APPLICATION FOR DISCHARGE OF PLANNING CONDITION CASE OFFICER REPORT

APPLICATION REFERENCE:	PL/2026/01590
APPLICATION TYPE:	Approval of details reserved by condition
SITE ADDRESS:	Bay Tree Barn, Lower Woodrow, Forest, Melksham, SN12 7RB
DEVELOPMENT DESCRIPTION:	Discharge of conditions 5 lighting & 7 fencing, walling, gates and means of enclosure of planning application PL/2025/04208 (Retention and extension of stable building to be used as an Alternative Provision of Education (Class F1(a)) and creation of associated parking and a fenced play area)
RECOMMENDATION:	Condition 5 of PL/2025/04208 is NOT DISCHARGED and Condition 7 is DISCHARGED

Figure 1: extract of proposed fencing

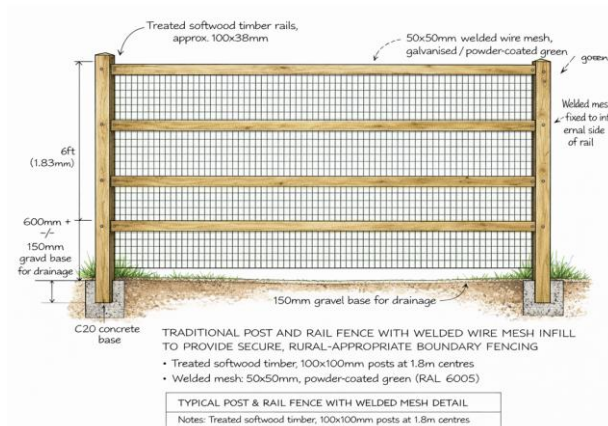
The Block plan provided indicates where fencing and 1no gate will be erected; plans provided show typical elevations and design of these boundary treatments.

The application site is rural, with no landscape designations attached and no protected trees or hedgerows existing at the site. The submitted proposed boundary treatments will ensure that the development is of an appropriate appearance in the rural landscape; the detail is consistent with the pre-commencement aims of condition 7 of PL/2025/04208 to such a degree that the fencing and gate can be erected in accordance with the plans provided.

Typical post & rail fence with welded mesh detail
